Re: Third Submission Review – Urban Cottages Jewell – Zoning Map Amendment, Site Plan
w/Adjustment and Final Plat
Application Number: **DA-2309-00**
Case Numbers: **1984-2057; 2022-4026-00; 2022-3022-00**

URBAN COTTAGES JEWELL

SITE PLAN WITH ADJUSTMENTS

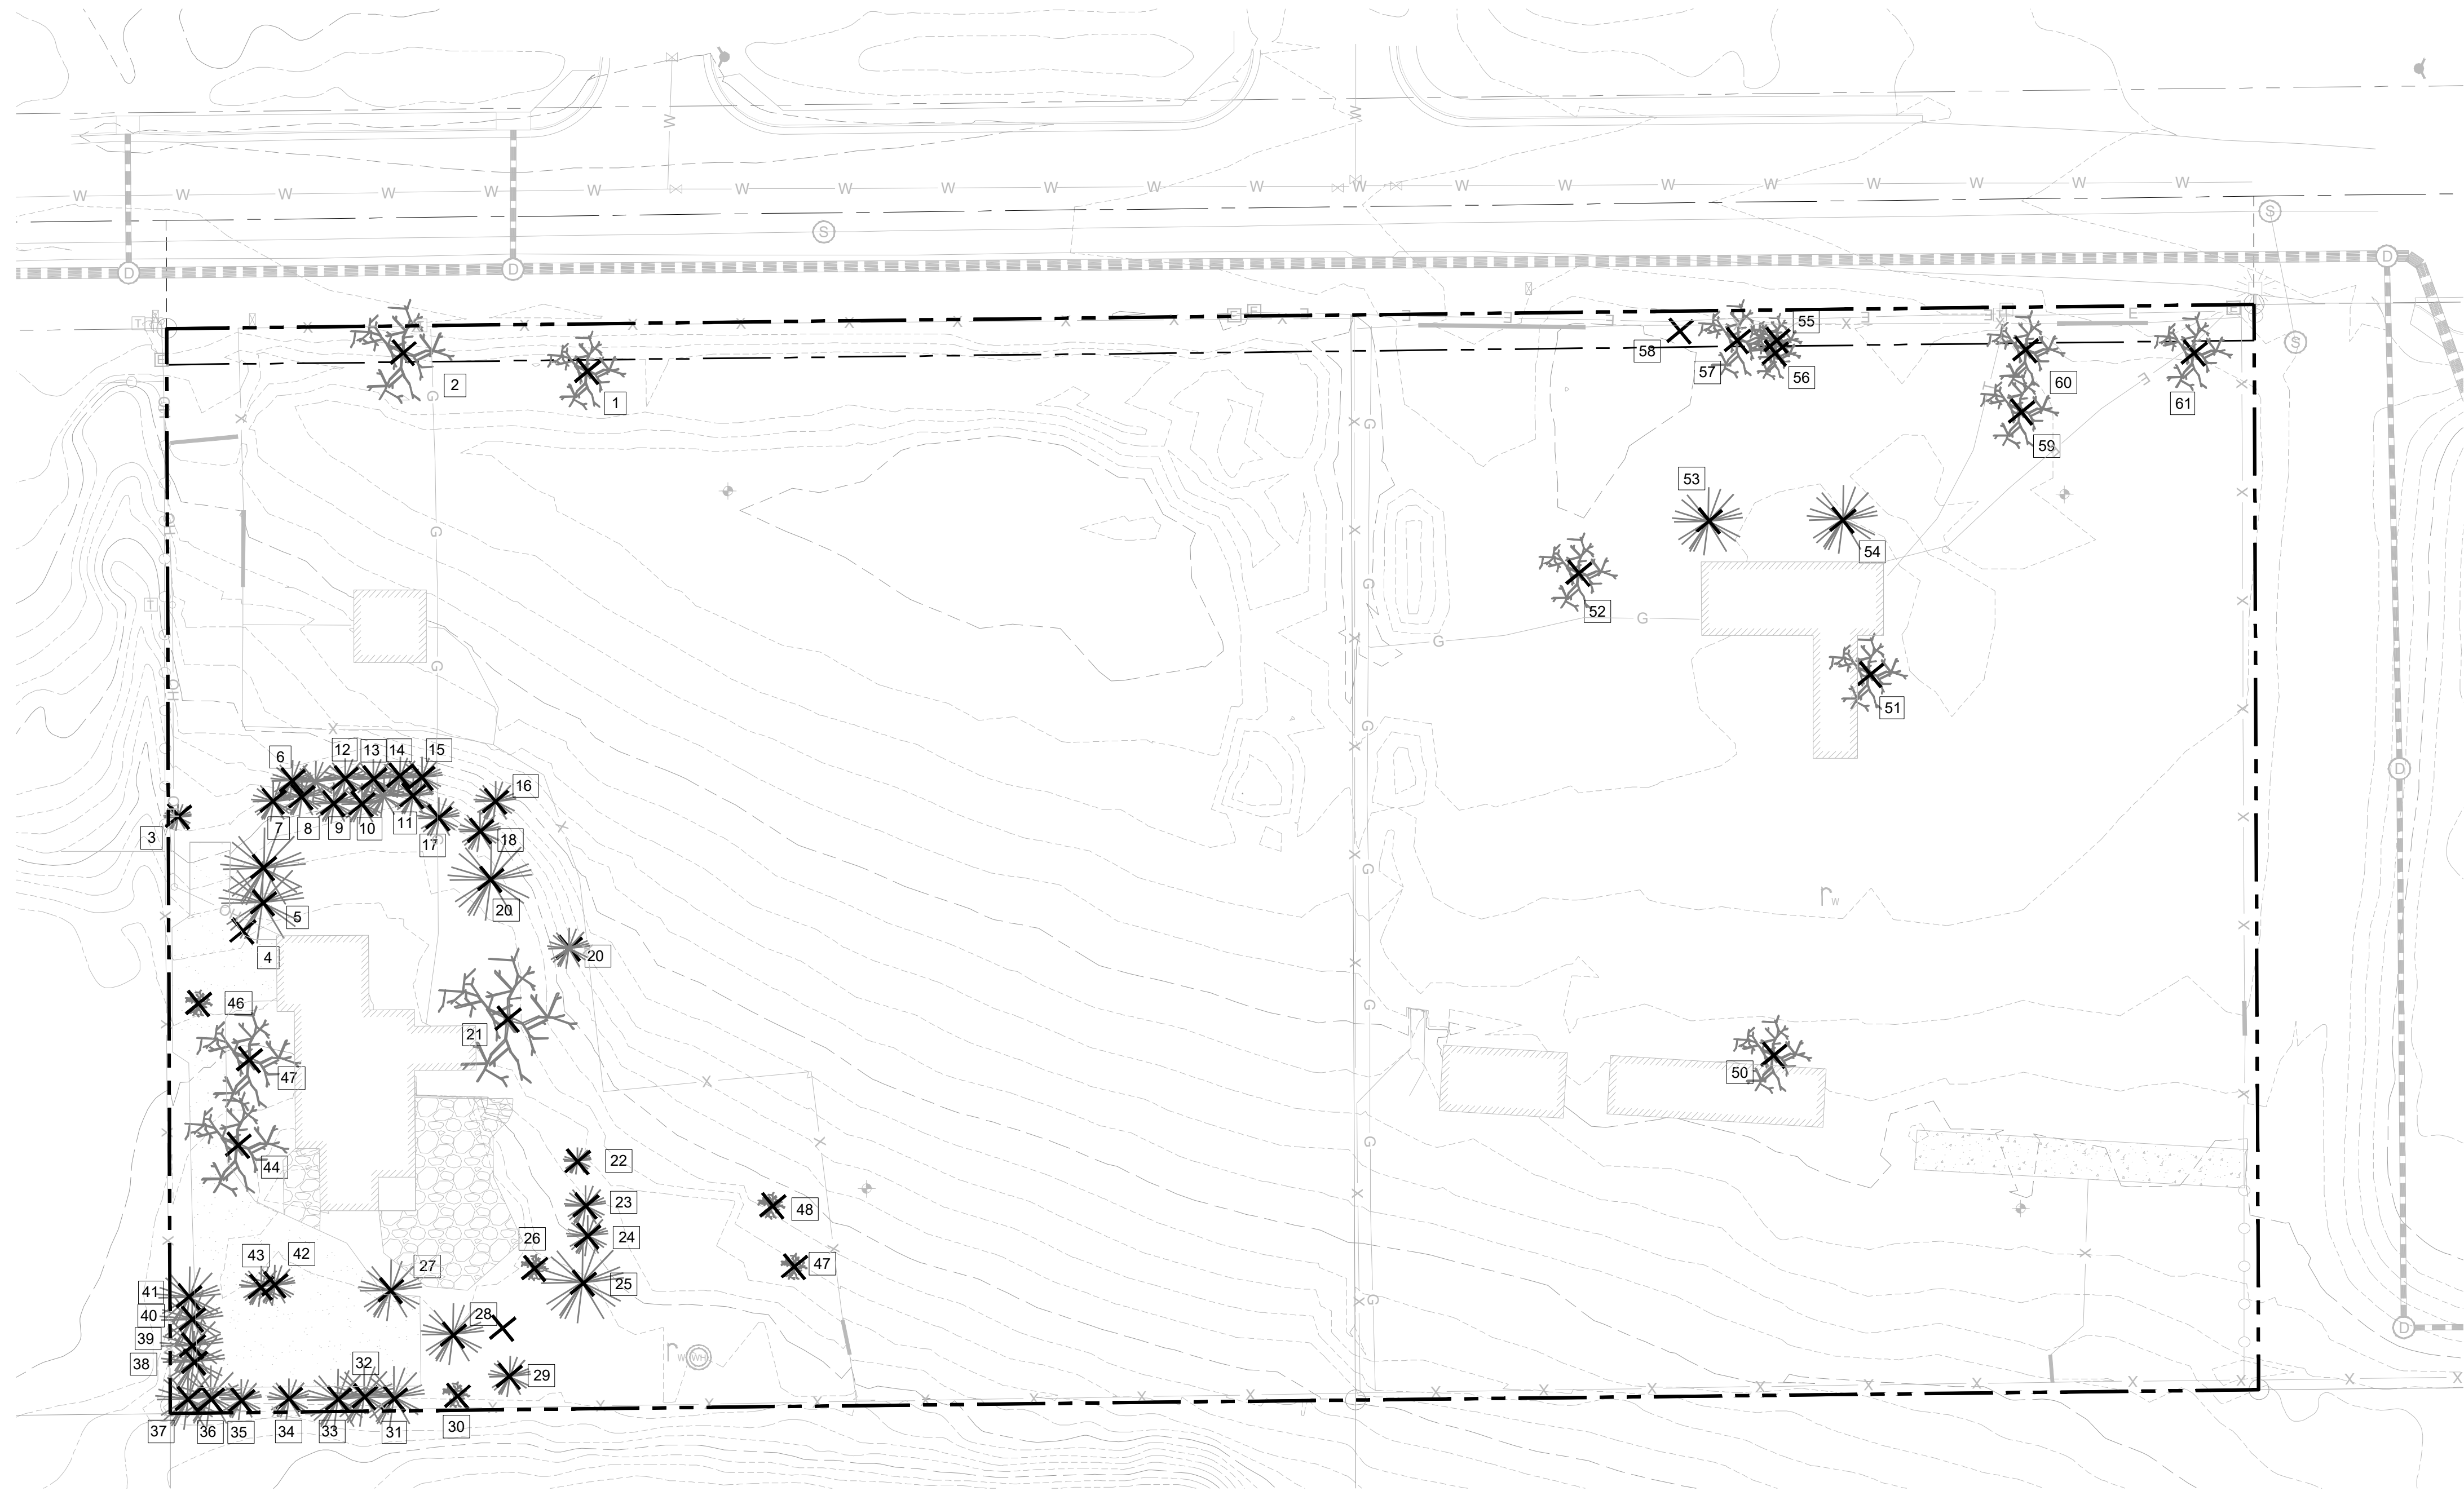
Per section 4.0.7.07.1 of the Roadway Manual, minimum 2' clear distance from a retaining wall to a property line.
